## **Appendix I – Modifications of Standards at SGH**

**From:** [Seth Timmerman](#)  
**To:** [Snyder, Chris](#); [Strack, Paul](#); [Muia, Maria](#); [Tom Franzen](#)  
**Subject:** Fwd: SGH Proposed MOS for Runway 15/33 OFA  
**Date:** Friday, January 31, 2020 3:41:57 PM

**From:** **Delaney, Katherine S (FAA)** <[Katherine.S.Delaney@faa.gov](mailto:Katherine.S.Delaney@faa.gov)>  
**Date:** Fri, Jan 31, 2020 at 3:38 PM  
**Subject:** SGH Proposed MOS for Runway 15/33 OFA  
**To:** Seth Timmerman <[stimmerman@springfieldohio.gov](mailto:stimmerman@springfieldohio.gov)>  
**Cc:** Erskine, Alex (FAA) <[Alex.Erskine@faa.gov](mailto:Alex.Erskine@faa.gov)>

**CROSSWIND RUNWAY 15-33 ALTERNATIVES  
 ALT. C-5 REQUEST FOR MODIFICATION TO STANDARDS  
 SPRINGFIELD-BECKLEY AIRPORT  
 SPRINGFIELD, OHIO**

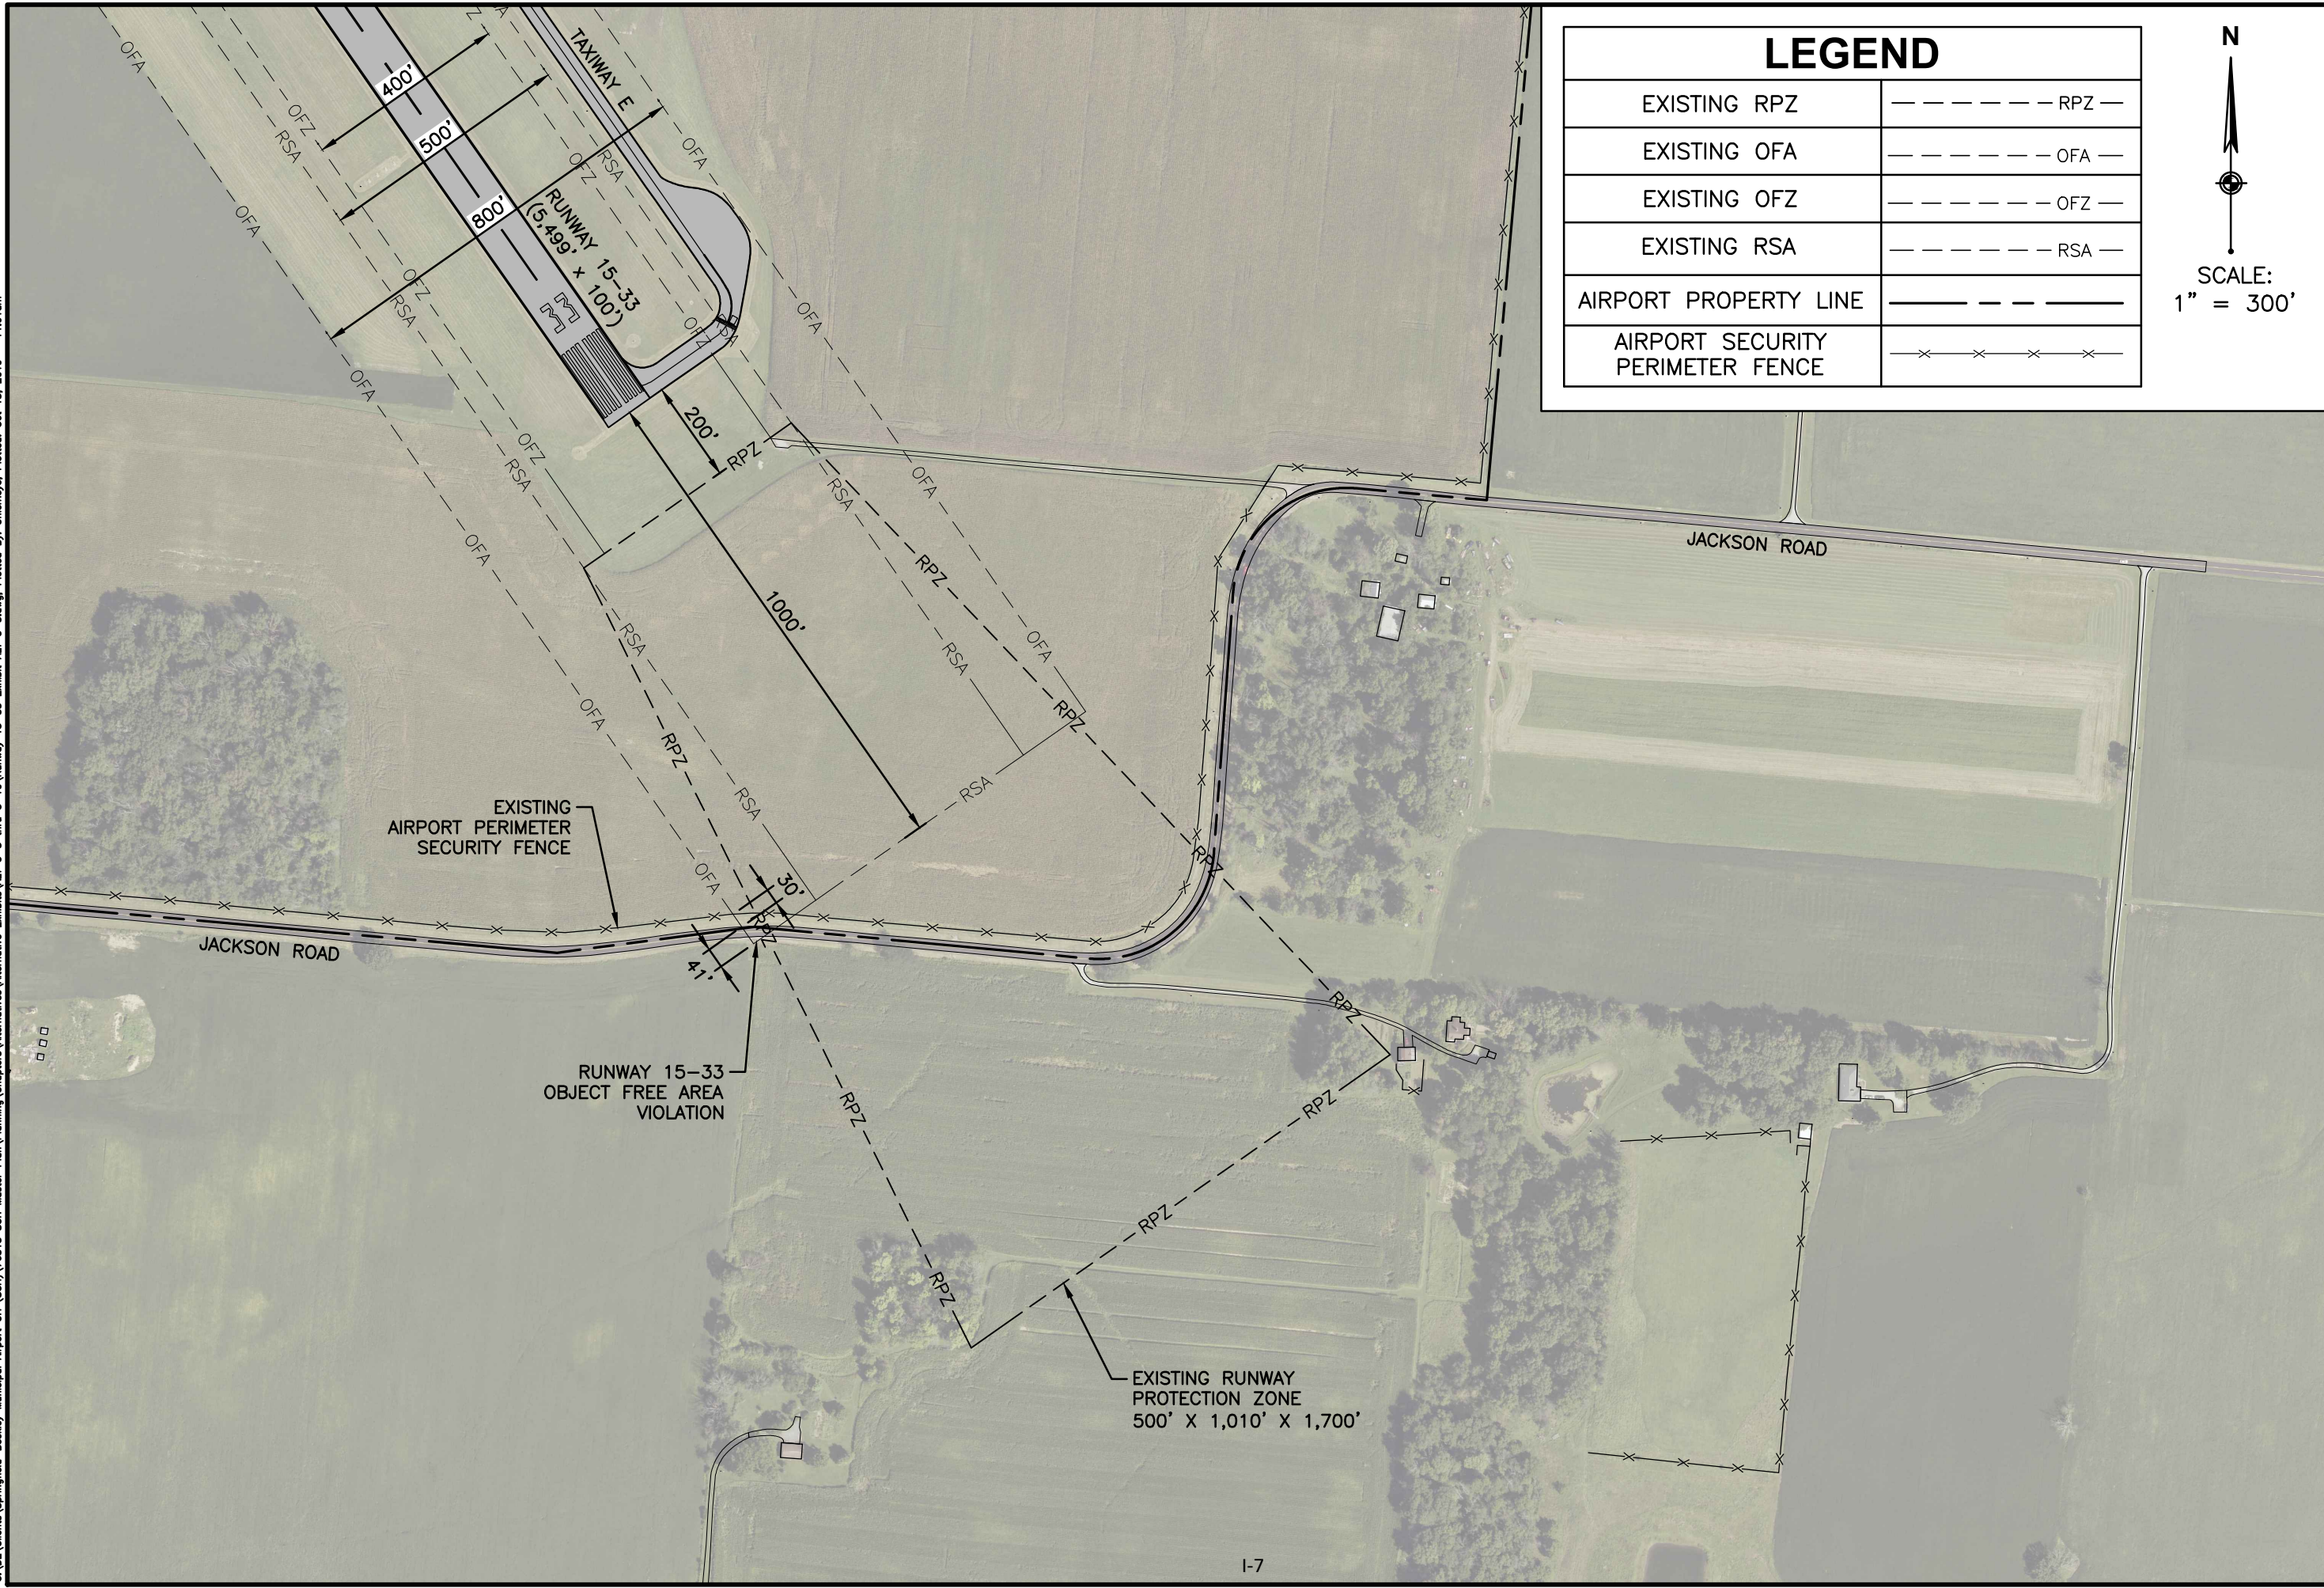
Allow airport security fence and county road to remain within the Runway OFA until the West Jackson Road can be relocated (See *attachment SGH\_OFA SQ Ft.pdf* and *attachment Runway 15-33 Exhibit ALT C-5.pdf*).

West Jackson Road and the Airport Perimeter Fence (south of Runway 15-33) currently penetrates the Runway OFA by 75 feet and are higher than the nearest point of the Runway RSA. Refer to the Attached Exhibit for details.

An exhibit is attached showing the critical aircraft nose wheel at the end of the RSA with the left landing gear on the edge of the RSA. This exhibit shows that the wingtip for the critical aircraft is protected as it will not be within the roadway area.

We have received some additional guidance regarding the proposed MOS for the Runway 15/33 OFA. Based on the draft ALP Sheet 4 you sent to Alex via email on 1/31/2020, there is a proposed fix to move the road outside of the OFA. Based on the airport proposing a fix to remove the road from the OFA, the FAA will not need to continue processing the MOS. I will be able to terminate the MOS once SGH submits the updated Airport Layout Plan for review and airspace. This approach cannot be followed if the ALP, when submitted, does not include the future road relocation.

**CROSSWIND RUNWAY 15-33 ALTERNATIVES  
 ALT. C-6 JACKSON ROAD RELOCATION (2 OPTIONS)  
 SPRINGFIELD-BECKLEY AIRPORT  
 SPRINGFIELD, OHIO**

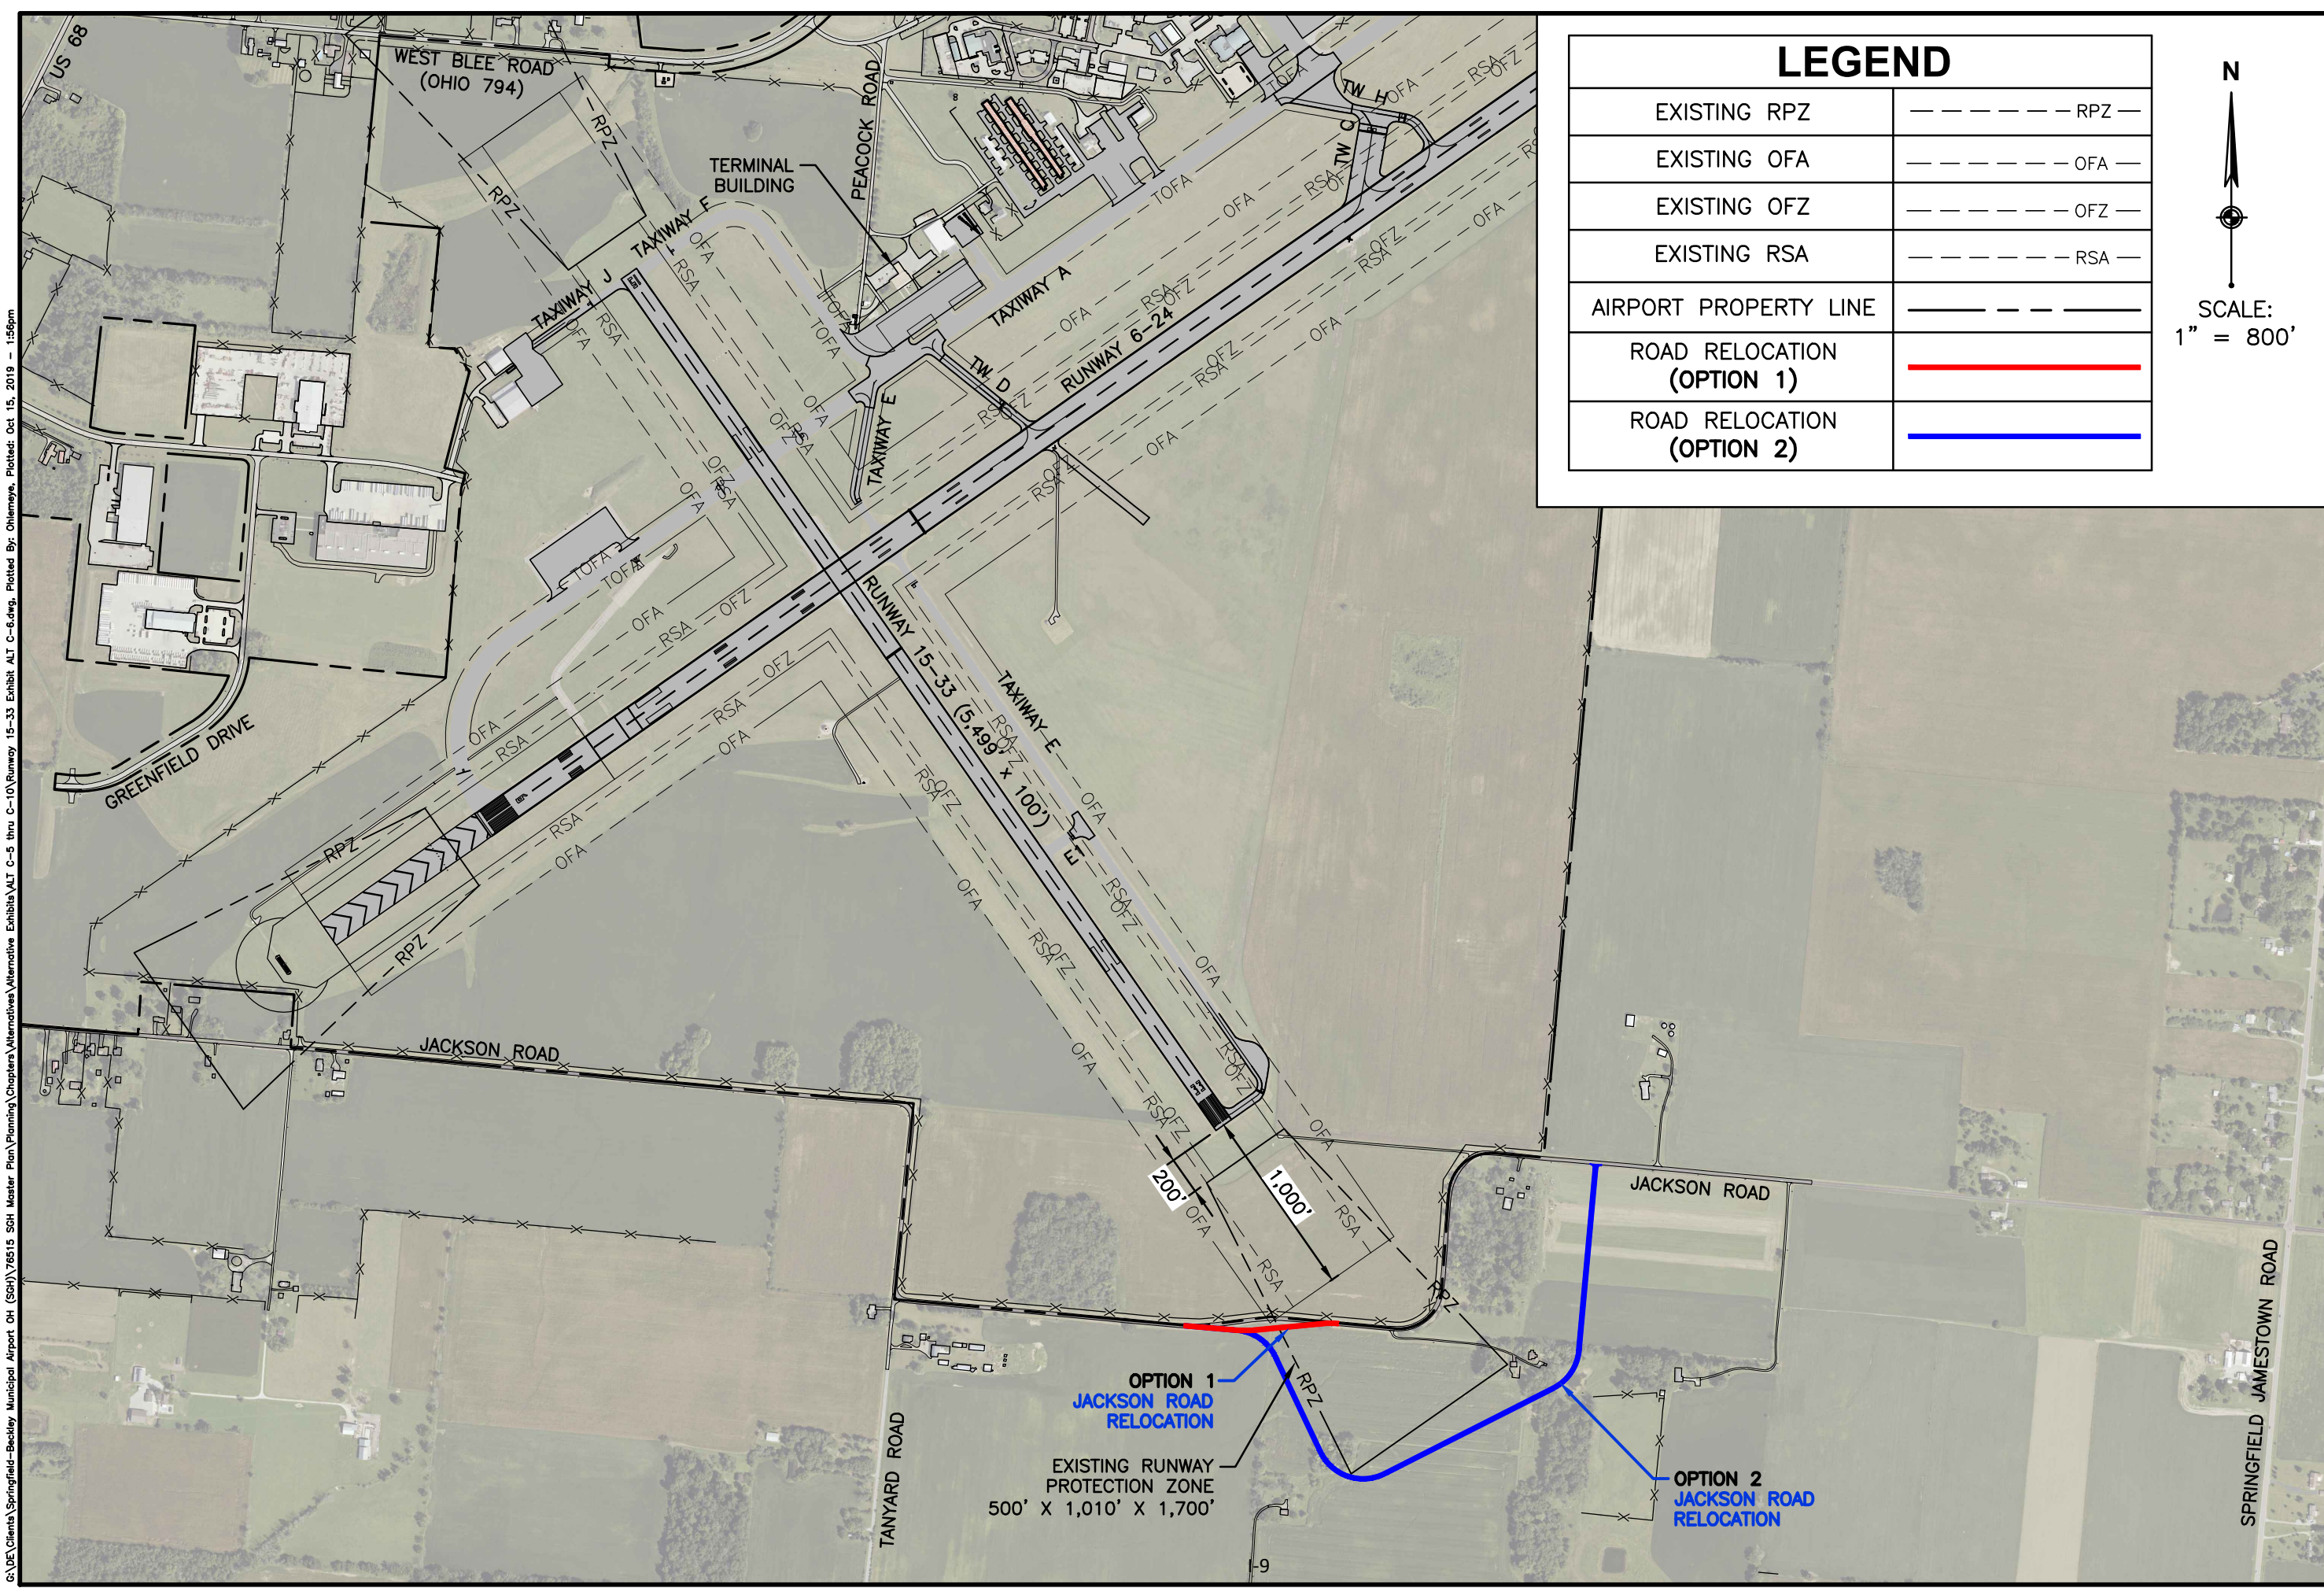
Alternative C-6 Option 1: Relocate West Jackson Road and Fence outside of ROFA (see *attachment Runway 15-33 Exhibit Alt C-6.pdf* (Option 1): This option relocates West Jackson Road outside the ROFA and requires the road to be shifted south to avoid the southwest corner of the ROFA of the end of Runway 33. The road remains in the RPZ as it does today. This option has the potential to take property from approximately 2 landowners and adds about 800 feet of road.

Alternative C-6 Option 2: Relocate West Jackson Road and Fence outside of ROFA (see *attachment Runway 15-33 Exhibit Alt C-6.pdf* (Option 2): This option reroutes West Jackson Road outside the ROFA and the RPZ. This requires the road to be shifted south and east to avoid the entire RPZ off the end of Runway 33. This option has the potential to take property from approximately 5 landowners and adds about 3500 feet of road.
